Technical Bulletin

Subject: Horn, Sound is Distorted

Number: 97-03

Model(s): EuroVan

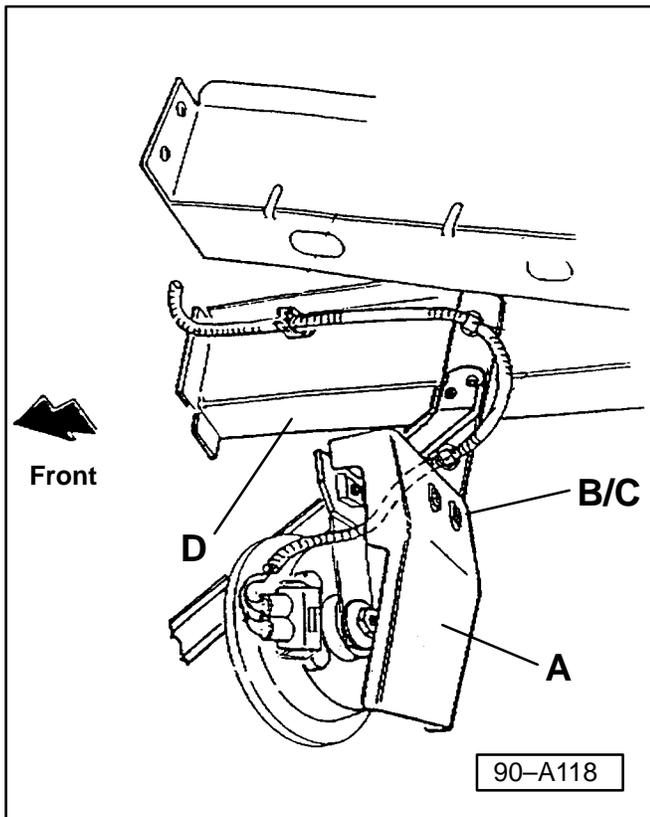
Horn, sound is distorted.

May be caused by water in horn.

Installation of additional splash shield beginning 11.96 with VIN 70_VH075830.

- Replace horn.
- Install splash shield -A- below long member using the following parts.

Item	Description	Part No.
A	Splash Shield	701 951 203
B	Screw Washer	N 013 967 1 N 904 995 01
C	Nut	N 045 427 1
D	Long member	NPN
